AC-20-03 (La Cima Multifamily Residential Design Standards)

Hold a public hearing and consider a request by Eric Willis for an Alternative Compliance to the various design requirements in Section 4.4.3.2 of the Multifamily Residential Design Standards in Ordinance 2014-35 for a proposed multifamily residential development located at the northwest corner of West Centerpoint Road and Flint Ridge Road, Hays County, Texas (A. Brake)

Schematic Site Plan

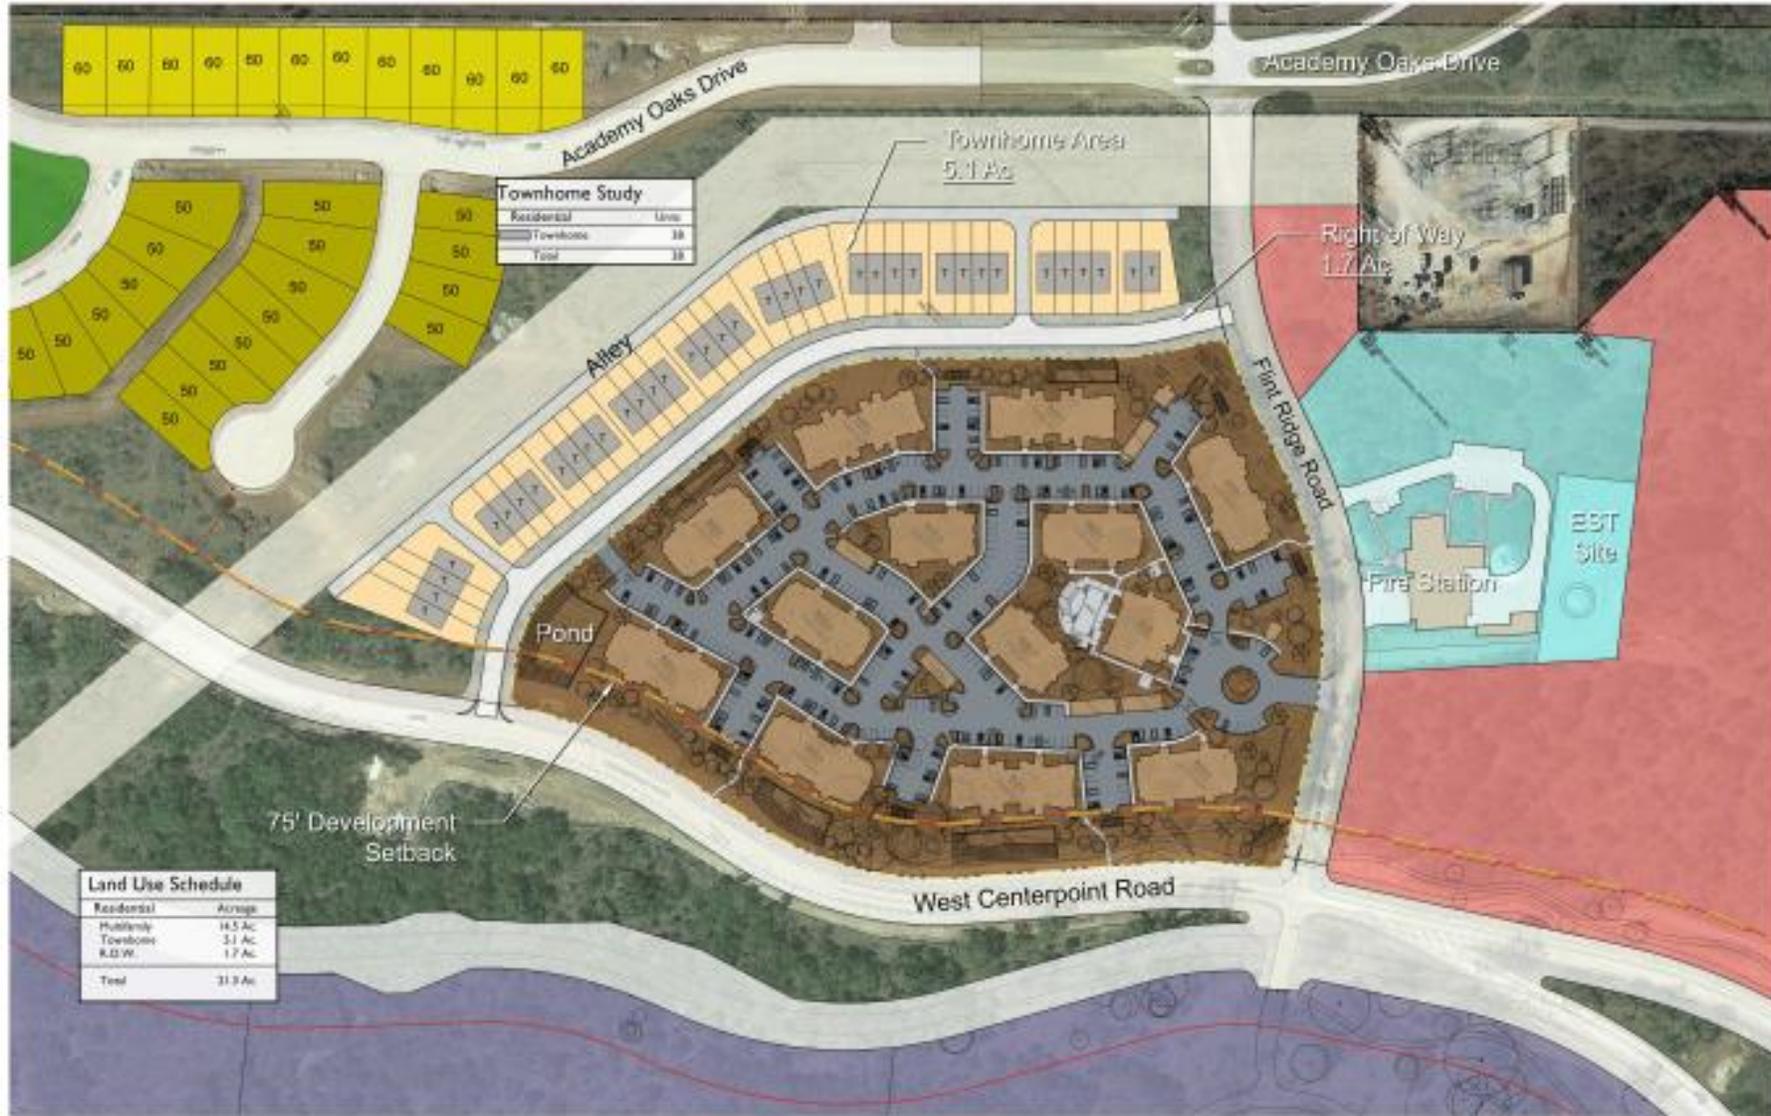
- **Alternative Compliance:**
Multifamily Residential Design Standards
 - block size
 - building location
 - fencing and screening
 - pedestrian and circulation
 - refuse and recycling dumpster

- +/- 12 Buildings
 - 288 Units

Section 4.4.3.2(1)(a)(iii) Block Requirements / Block Size

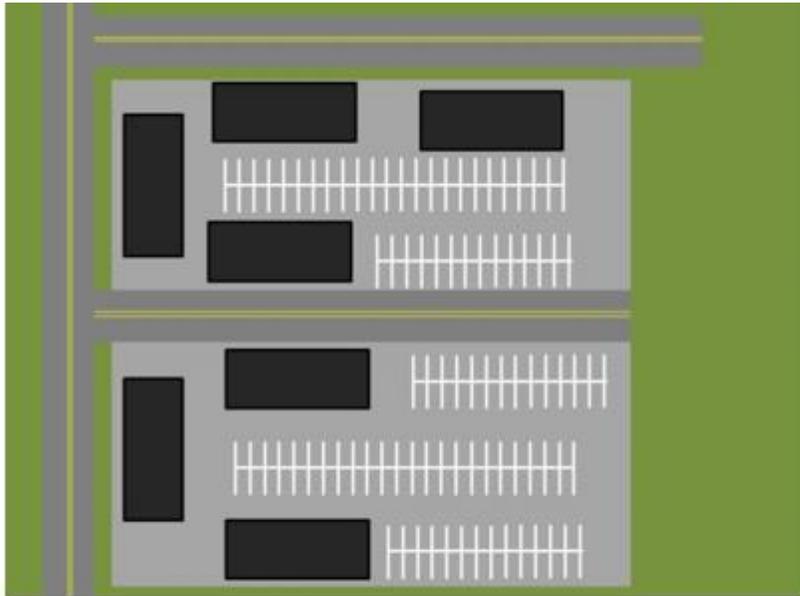
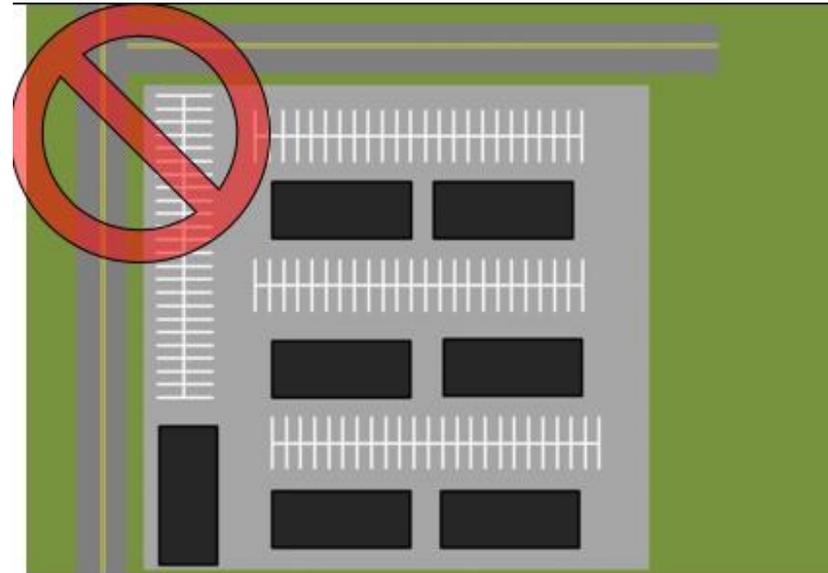
Code Requirement: All blocks shall be limited to a maximum size of seven (7) acres

Applicant Request: A maximum block size of 14.5 acres.

Building Location

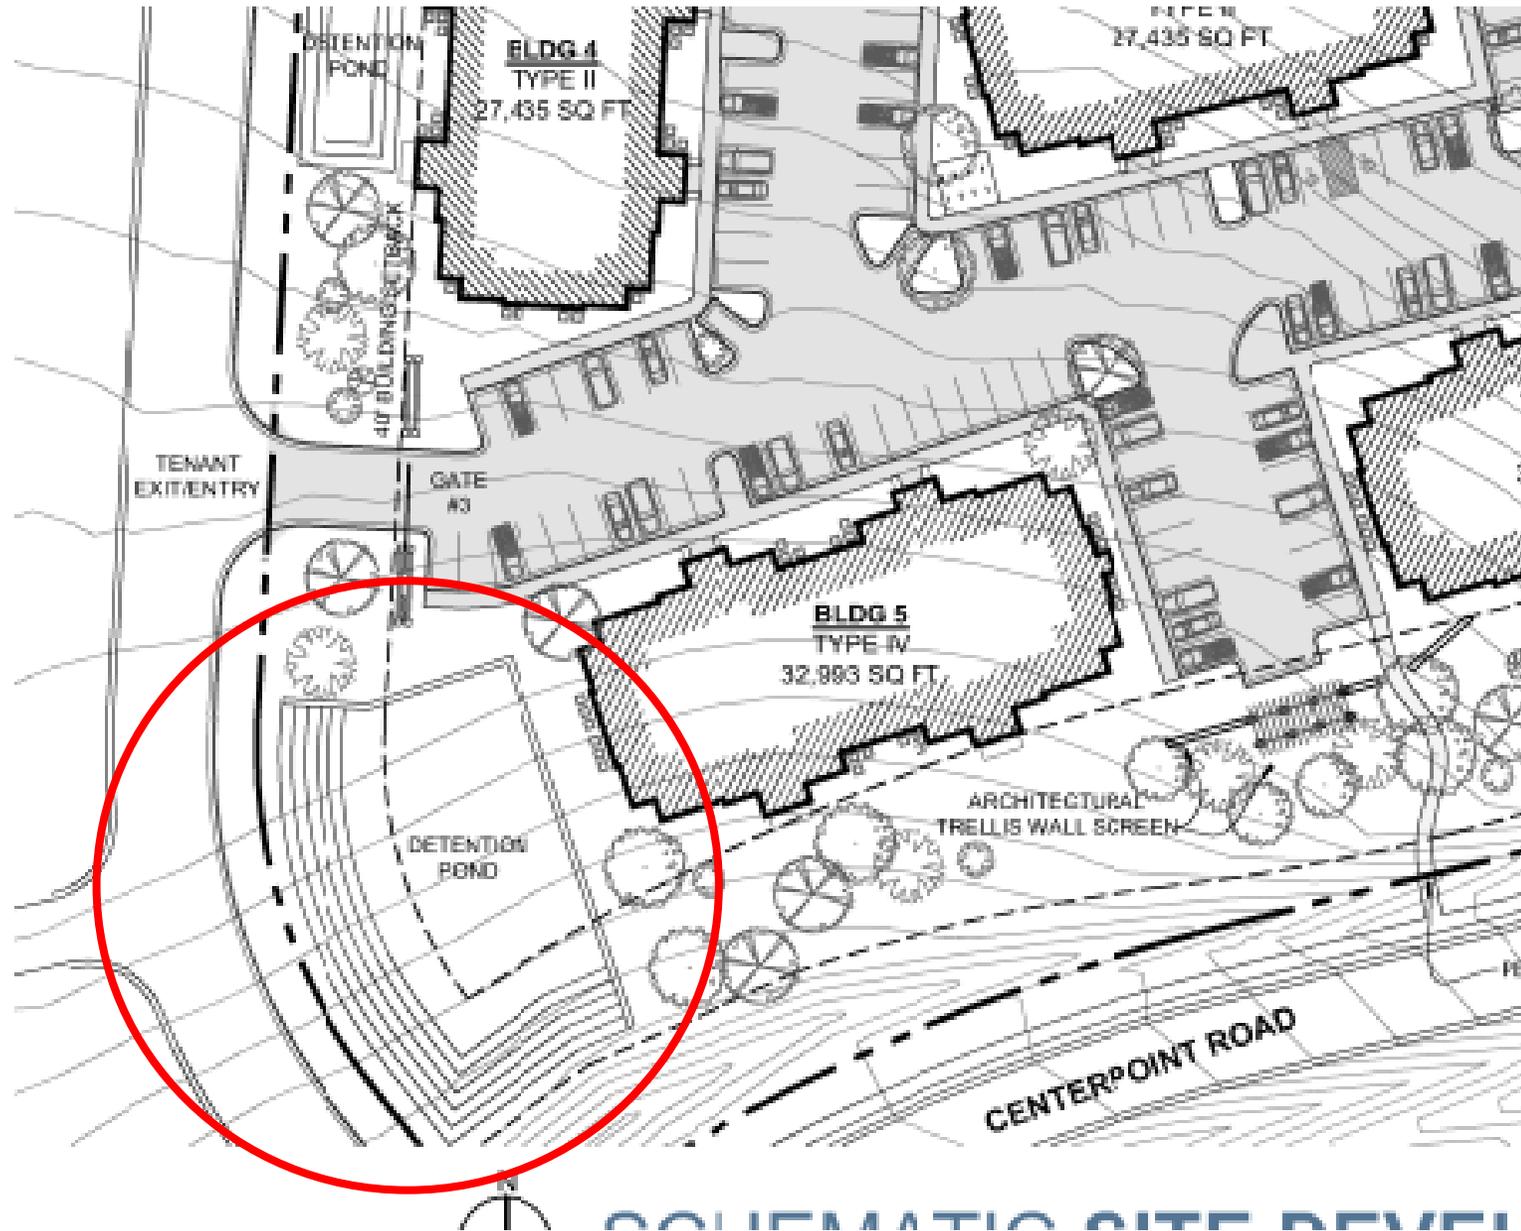
Code Requirement: At least 50% of the frontage along streets shall consist of principal buildings, publicly accessible plazas, transit stops, or other functional open space focused on the corners of the block.

Applicant Request: Building 5 is adjacent to a detention pond*. This particular pond, according to applicant, is at the lower end of the site and best location to catch runoff.

Pedestrian Access

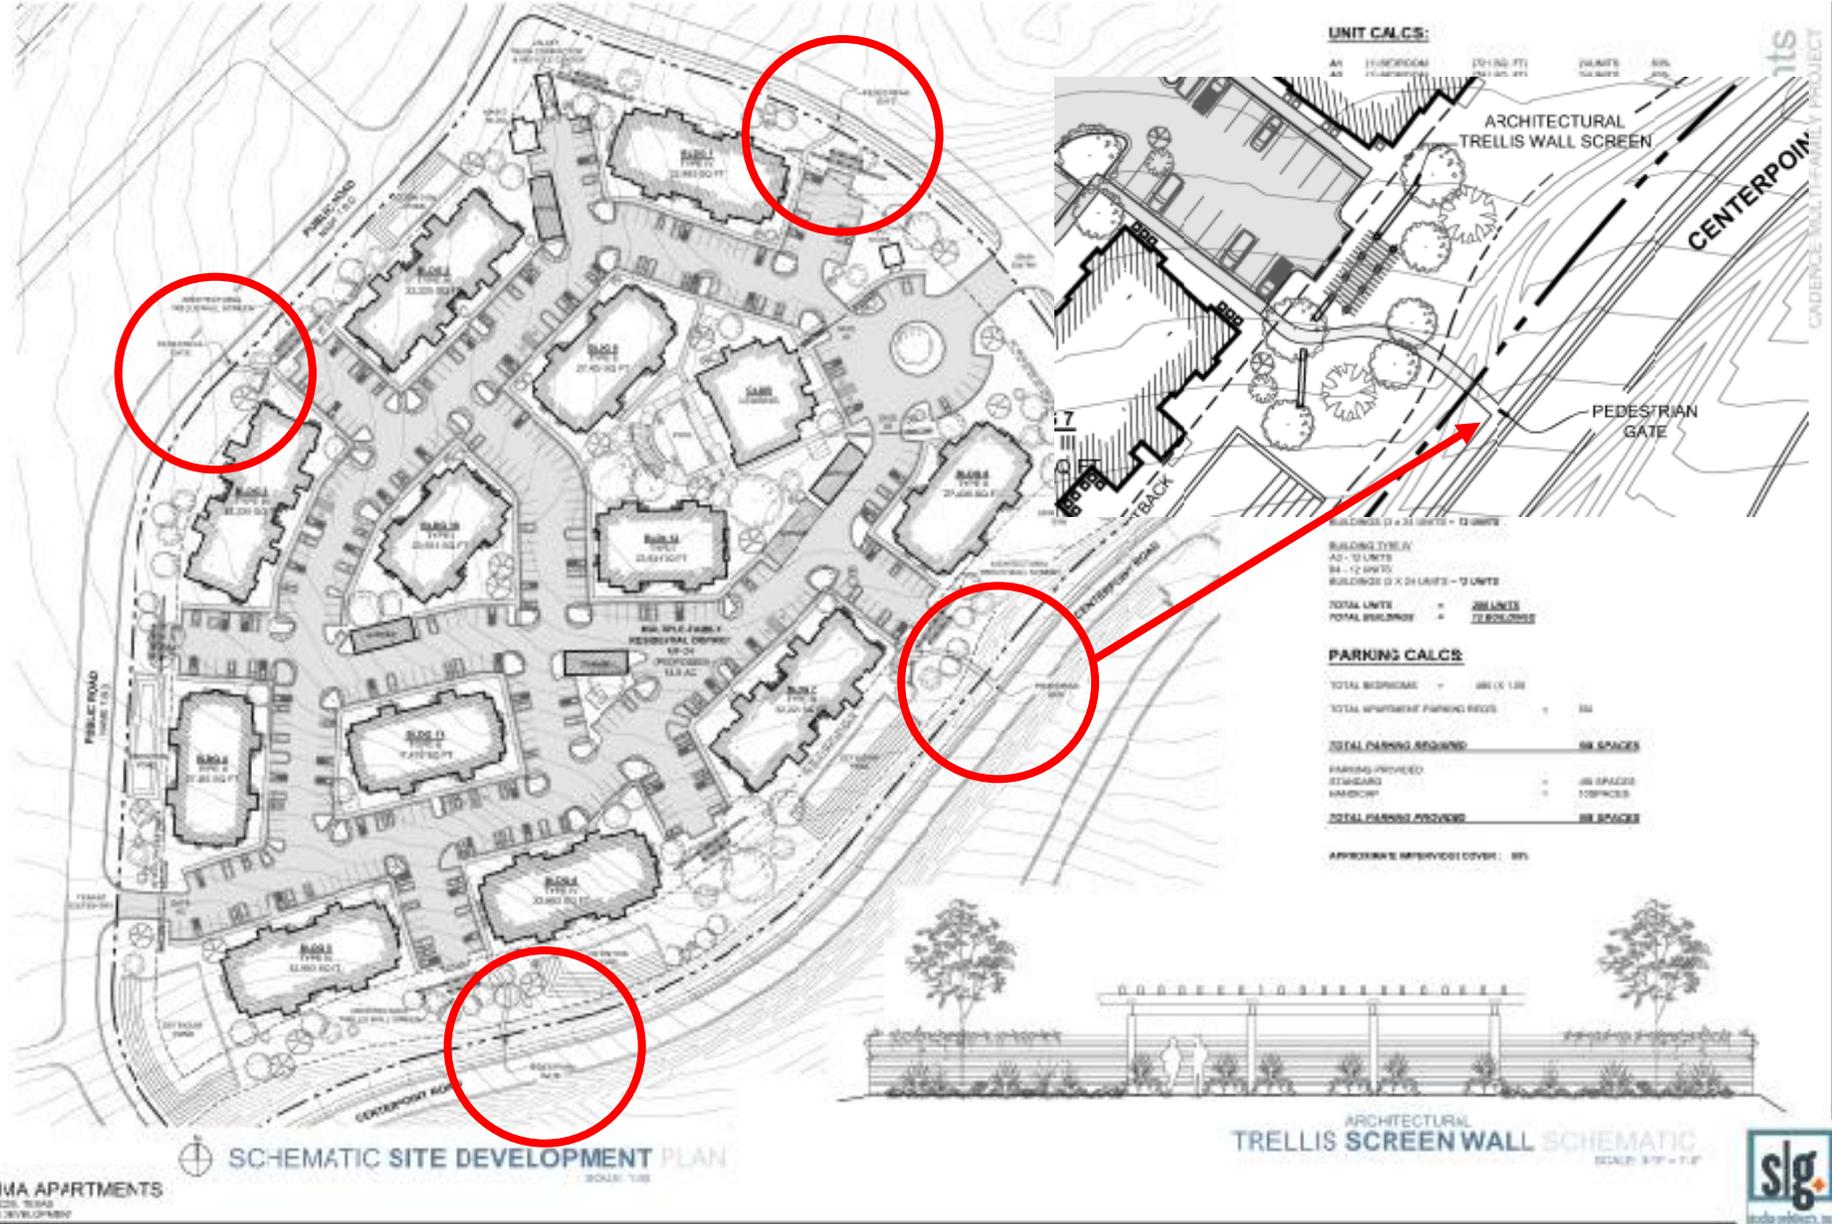
Code Requirement: Pedestrian entrances shall connect sidewalks to the internal walkway network and shall be open and not gated.

Applicant Request: Gated pedestrian entrances with keypads*

Section 4.4.3.2(1)(m) Refuse and Recycling Dumpsters

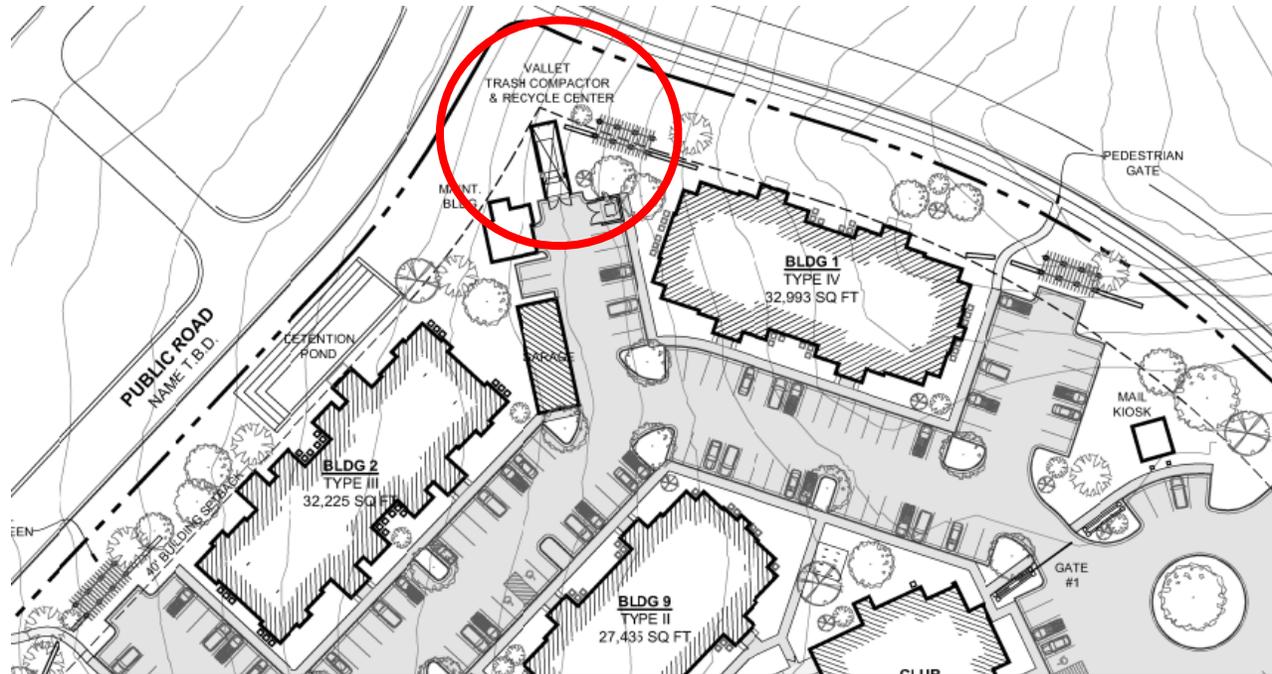
Code Requirement: All multifamily developments shall provide both trash and recycling dumpsters located next to each other. Both shall be located within 500 feet of the entrance to each ground floor unit measured from the front of the entrance of the unit and along improved pedestrian paths.

Applicant Request: Utilize a single valet trash compactor and recycle center – between Buildings 1 and 2
